Chapel Downs Primary School – Notice of Requirement

Integrated Transportation Assessment

February 2024

Appendix D – Consultation Summaries and Responses

Figure 3: Existing Bus Services and Stops

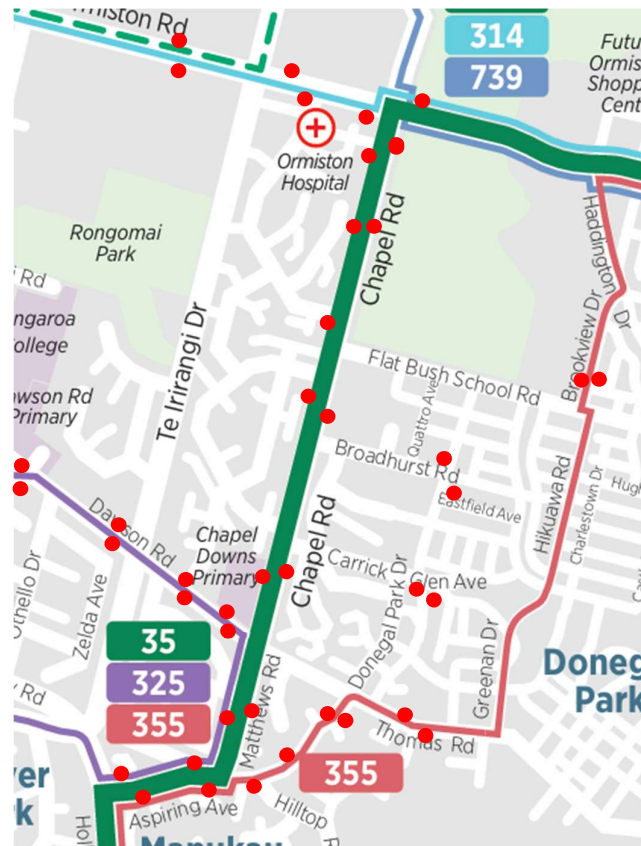
2.3	It would be useful to identify on a plan the location of the bus stops. The report should comment on the availability of pedestrian crossing facilities in the vicinity of the bus stops.	Accepted. Figure 3 within the updated ITA address this matter by showing the location of the surrounding bus stops near the school.

Figure 12: Indicative Future Enrolment Zones

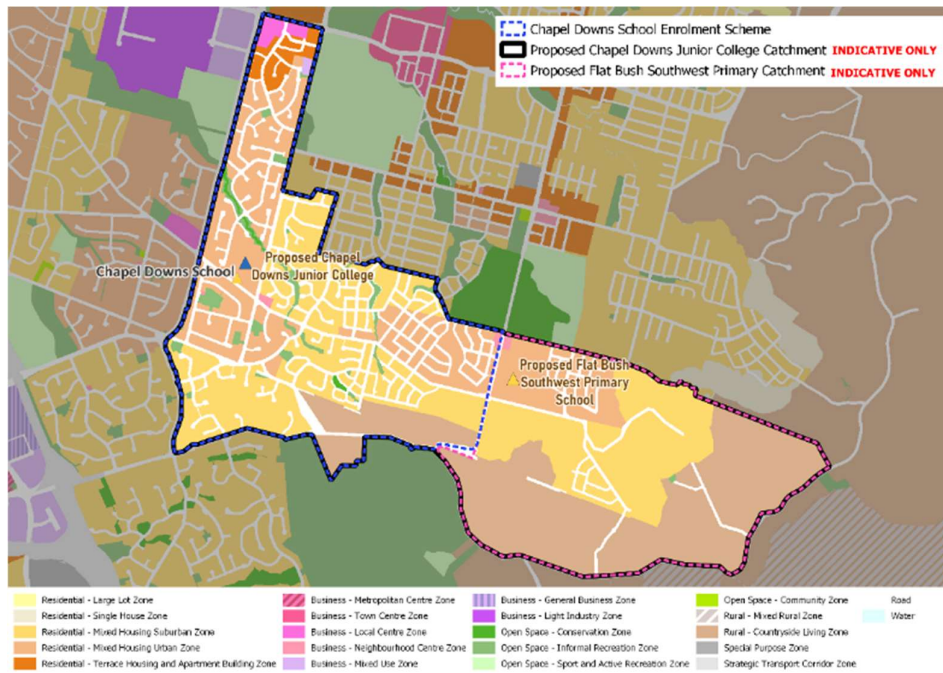
2.2	It would be useful to include a plan of the school catchment overlaid on top of the AUP zoning for the area (I note the existing school catchment is shown on Figure 6).	Accepted. This information has been captured in a revised Figure 12 within the updated ITA.

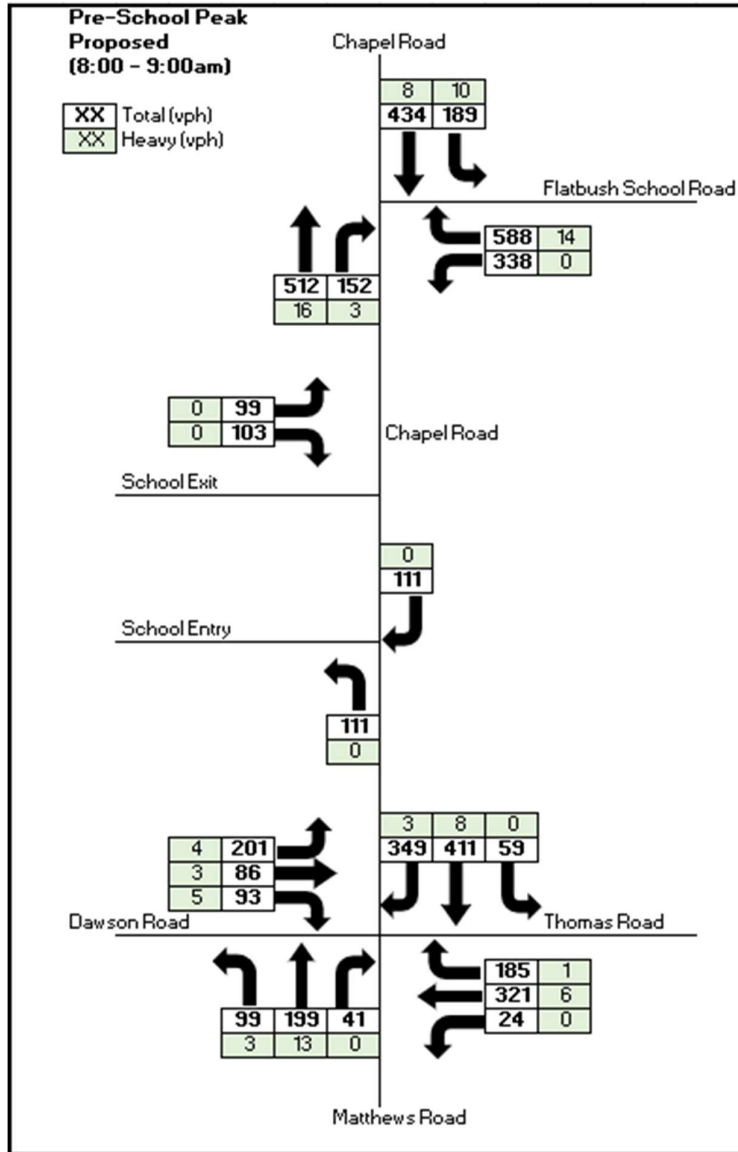
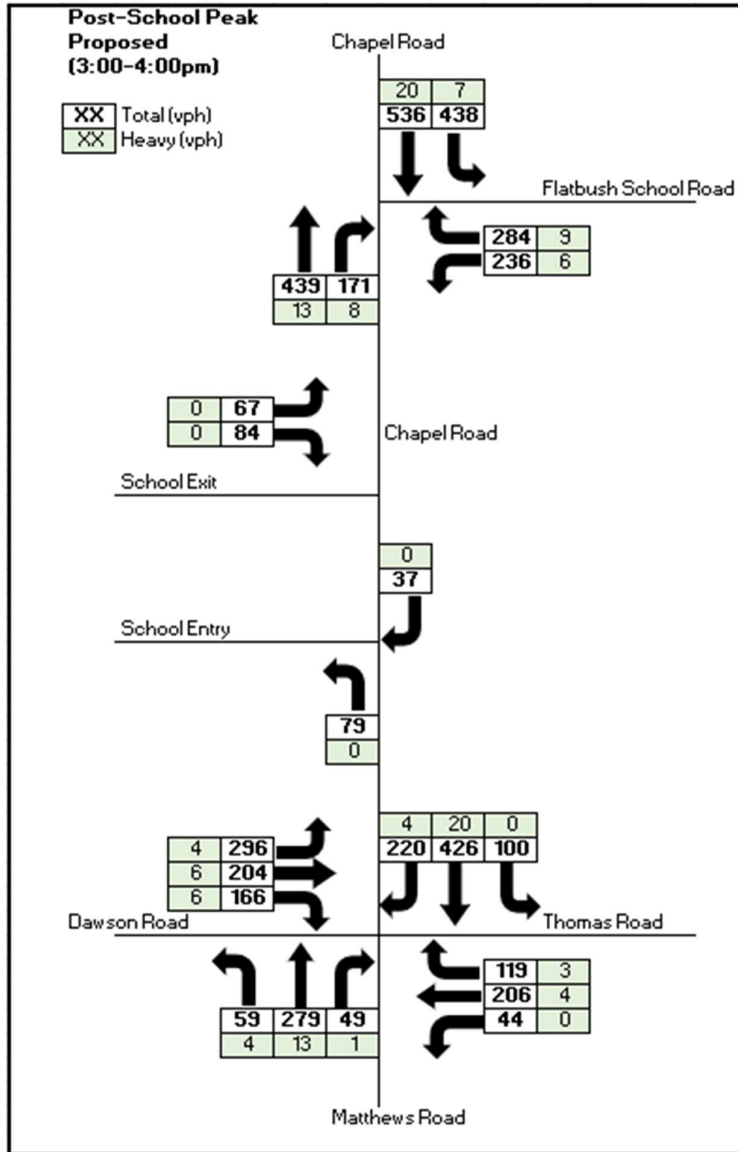
<p>It would be useful to add the equivalent of figures 7 and 8 showing future numbers.</p>	<p>The ITA has been updated to address the future (+200vph) scenario (See Section 6.3).</p>

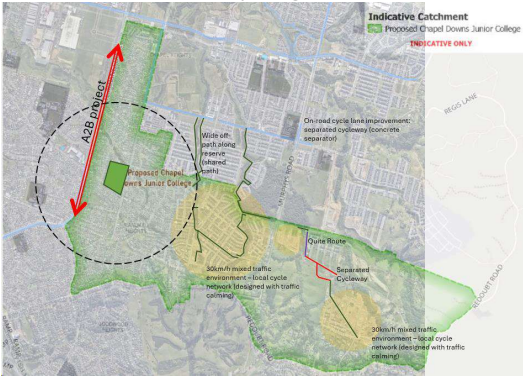
Signal crossing on Murphys Road for pedestrian (mid-block crossing) would need to be investigated. Indicative locations could include at either of one of the two locations shown below.	<p>The current NOR process does not propose or require such mitigation. Future OPW / Travel Plan assessments will be able to quantify the need or otherwise for any physical mitigation of this nature and to integrate with other AT (and developer-led) work that might address this matter. It is preferred that consideration of such major changes to the Murphys Road corridor be undertaken in an integrated matter not simply as a mitigation. There is also a much wider consideration of the NZUP Murphys Road project to be undertaken (by AT and formerly Waka Kotahi) that will likely address these and other transport matters for the wider benefit of the Murphys Road community.</p> <p>Such wider area considerations are beyond the current scope of the NOR process and are best addressed by AT in its role as network managers. Furthermore, the current</p>
